V2500 Propulsion System — Nacelle

NACELLE - EXHAUST - LOCKOUT FEATURE, THRUST REVERSER -
MODIFICATION OF

V2500-D5

V2500-NAC-78-0113

Outboard Seal Block and Main Slider Modification
Figure 1 (Sheet 1)

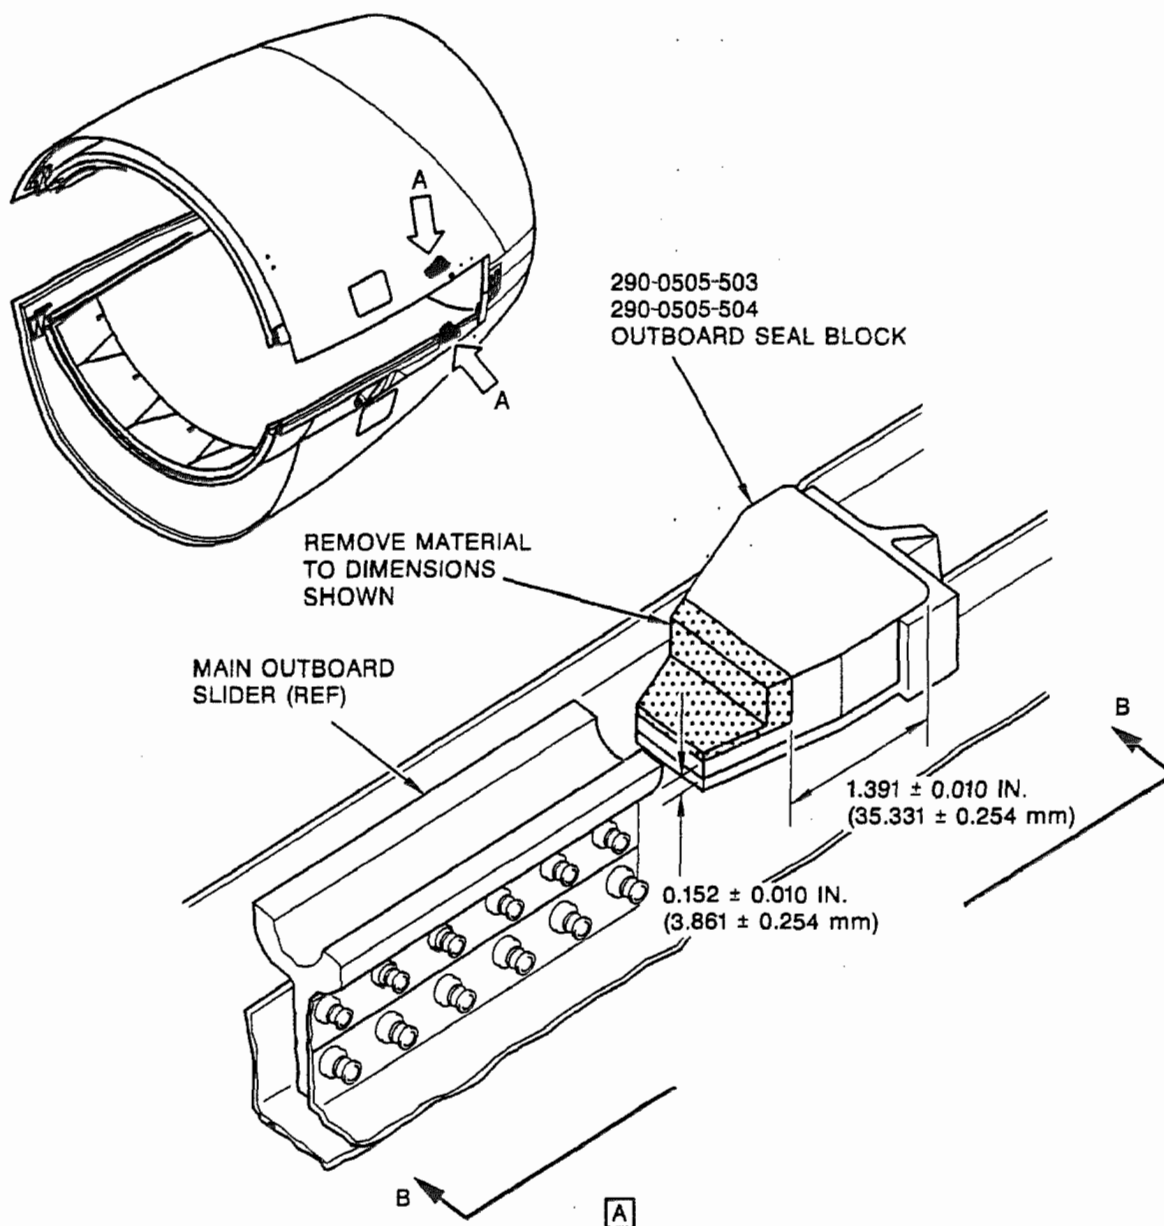
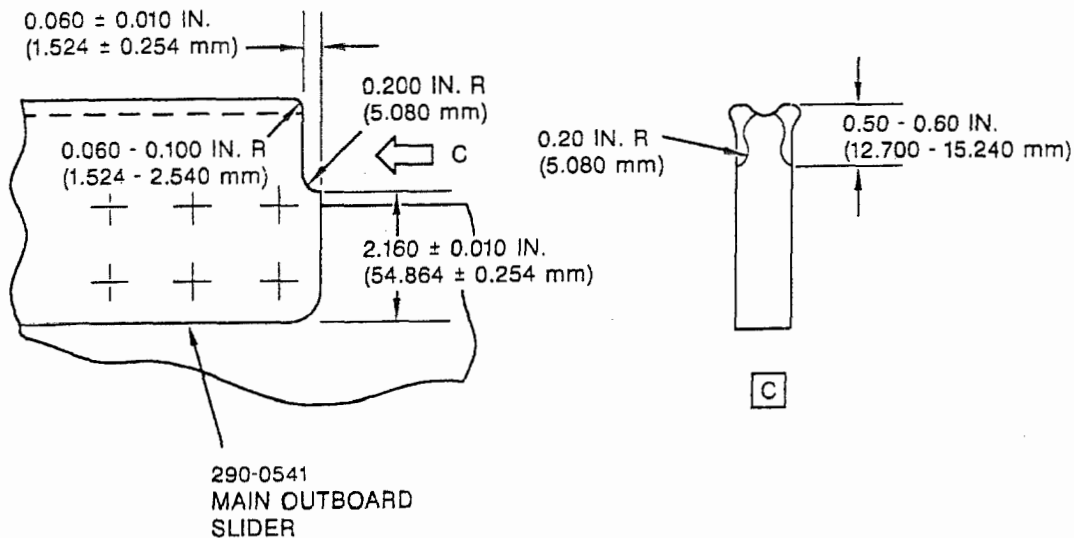
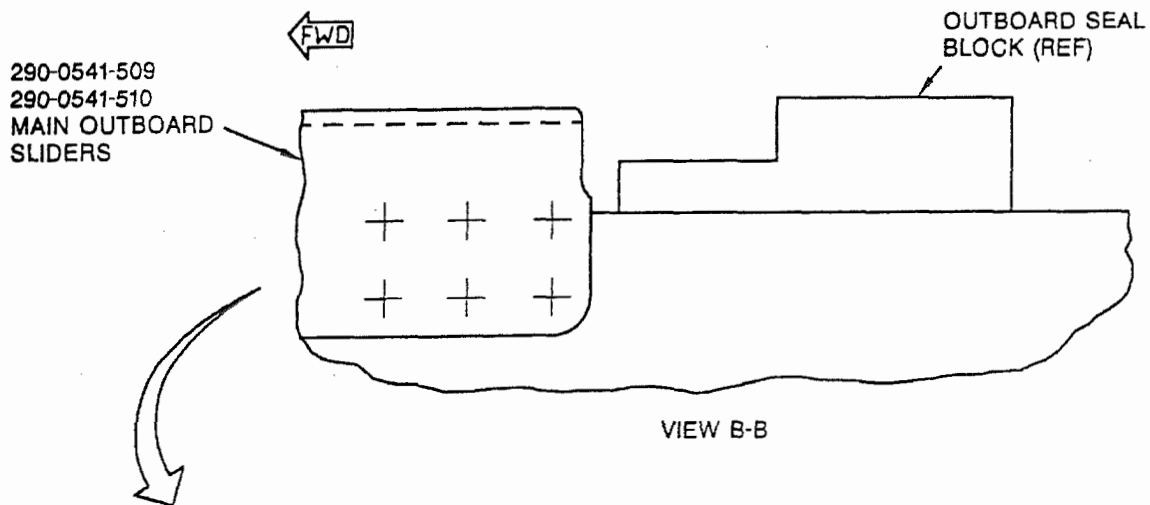
The outboard main slider, stow lockout plug, and lockout plug retainer will be machined and the outboard seal block trimmed to prevent any future interference.

- (1) Modify the 290-0505-503 and 290-0505-504 outboard seal blocks. Refer to Figure 1.
 - (a) Remove the indicated material from the 290-0505-503 and 290-0505-504 seal blocks on the upper and lower translating sleeves with a knife.
- (2) Modify the 290-0541-509 and 290-0541-510 main outboard sliders on the upper and lower translating sleeves. Refer to Figure 1.
 - (a) Remove the indicated material from the 290-0541-509 and the 290-0541-510 main outboard sliders and radius the corners with a grinder as shown in Figure 1.

Stow Lockout Plug and Stow Lockout Plug Retainer Modification
Figure 2 (Sheet 1)

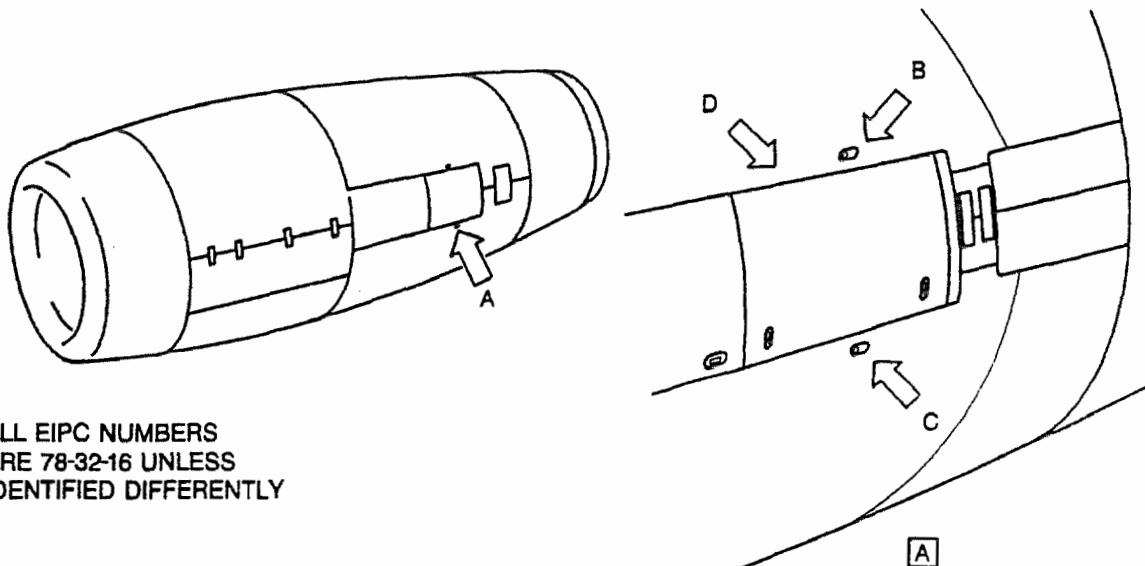
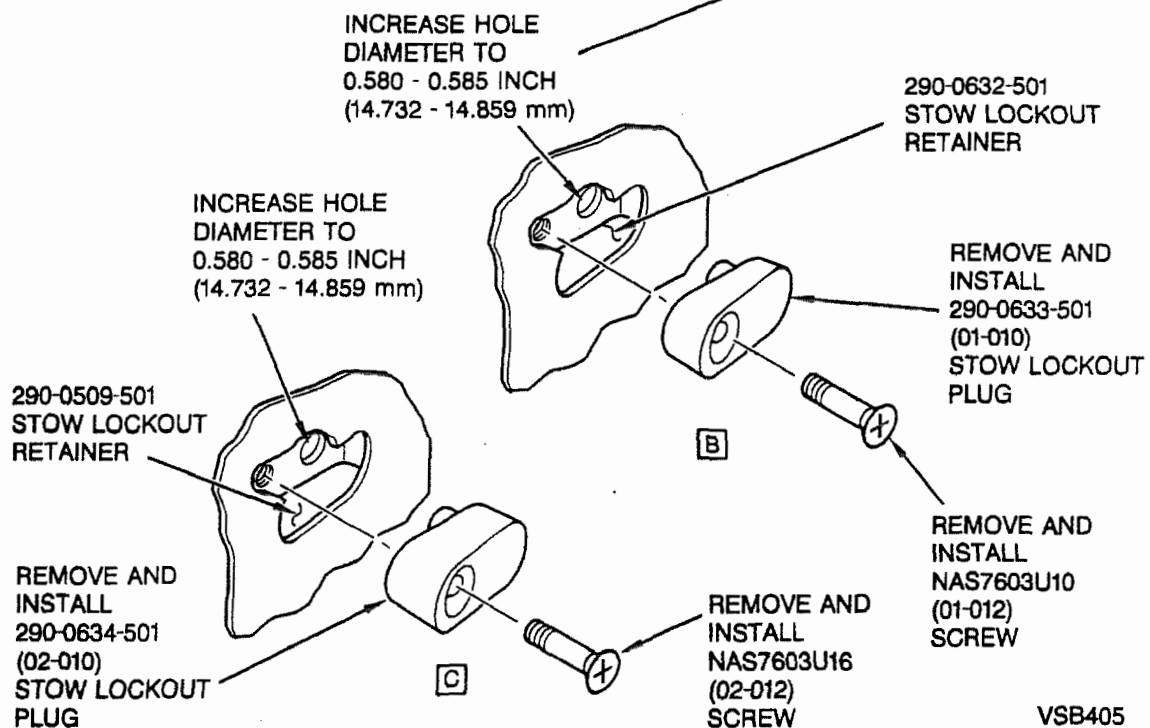
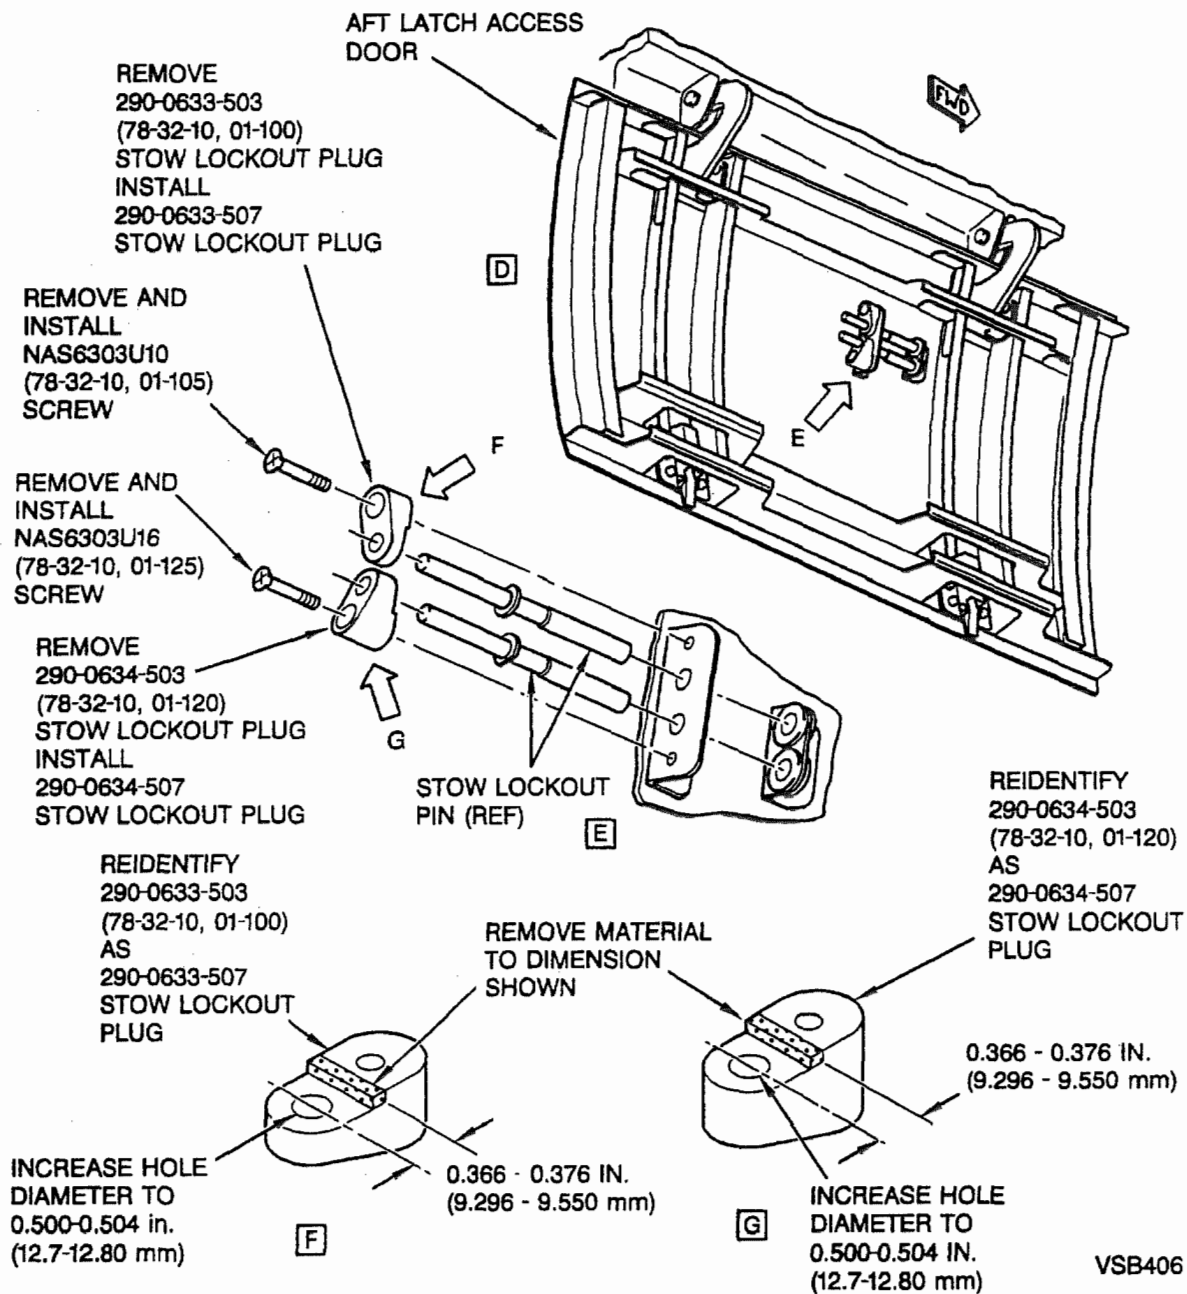
- (h) Cure the primer for seven hours at room temperature or for 40 minutes at 140°-180°F (60°-82°C) with an explosion-proof heat lamp.
- (3) Modify the 290-0632-501 and 290-0509-501 stow lockout retainers. Refer to Figure 2.
- (a) Remove the NAS7603U10 screw and the 290-0633-501 stow lockout plug from the 290-0632-501 stow lockout retainer on the upper translating sleeve. Retain screw and plug for installation.
 - (b) Remove the NAS7603U16 screw and the 290-0634-501 stow lockout plug from the 290-0509-501 stow lockout retainer on the lower translating sleeve. Retain screw and plug for installation.
 - (c) Increase hole diameters in the 290-0632-501 and 290-0509-501 stow lockout retainers as shown in Figure 2.

- (4) Modify the 290-0633-503 and the 290-0634-503 stow lockout plugs. Refer to Figure 2.
 - (a) Remove the NAS7603U10 screw and 290-0633-503 stow lockout plug and NAS7603U16 screw and 290-634-503 stow lockout plug from the latch access door on the upper thrust reverser half. Keep the screws for later installation.

- (b) Machine the indicated material from the 290-0633-503 and the 290-0634-503 stow lockout plugs.
 - (c) Increase the hole diameters in the 290-0633-503 and 290-0634-503 stow lockout plugs as shown in Figure 2.
